Service Bulletin

Bulletin No.: 19-NA-150

Subject: Information on Rough Idle, Malfunction Indicator Lamp (MIL) Illuminated After Engine Repairs - DTC P0016 Set

Brand:	Model:	Model Year:		VIN:		Engine:	Transmission:
		from	to	from	to		
Chevrolet	Colorado (VIN S and T)	2017	2019			LGZ	
GMC	Canyon

5368138

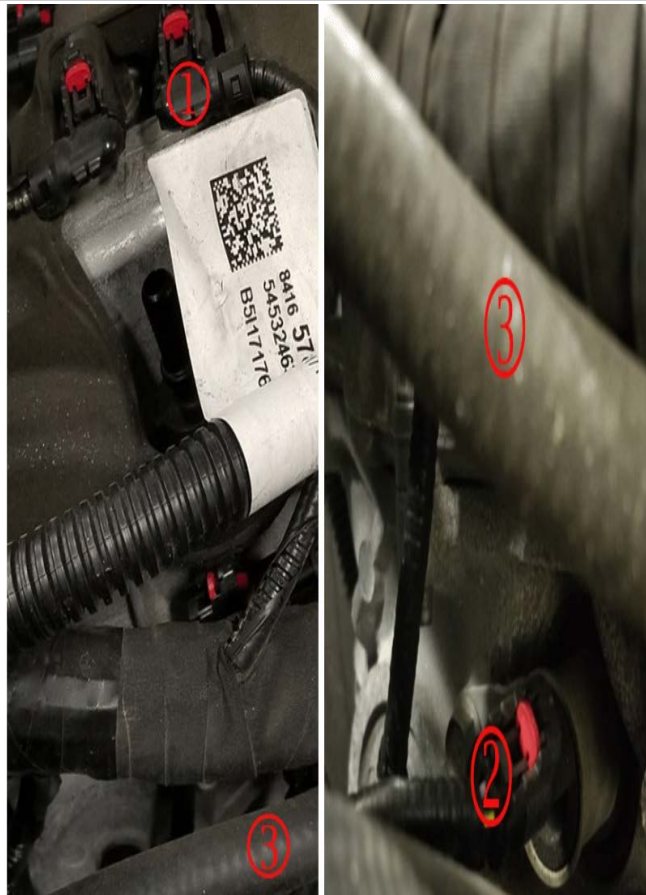
Involved Region or Country	North America
Condition	<p>Some technicians may find one or more of the following conditions after an engine repair that included removal and re-installation of the engine wiring harness on the right front side of the engine:</p> <ul style="list-style-type: none"> • MIL Illuminated with DTC P0016 (Crankshaft Position - Intake Camshaft Position Not Plausible Bank 1) set. • Rough Idle
Cause	<p>The wiring connectors for the intake camshaft actuator solenoid bank one on top of the engine and the connector for the intake actuator park lock solenoid in the front of the engine for bank one, may have been swapped.</p> <p>⇒ These two connectors are identical and can only be identified by wire color in the connector.</p>
Information	Remove the connector and look at the schematic in service information to compare and ensure the correct connector is plugged into the actuator and lock solenoid.

1. Bank 1 intake actuator
 2. Bank 1 intake park lock solenoid
 3. Same hose in both pictures shown for location.
- If they are incorrect swap them back and clear the code to verify repair.
 - If they are already in the correct location then refer to the correct service information diagnostic for this DTC.
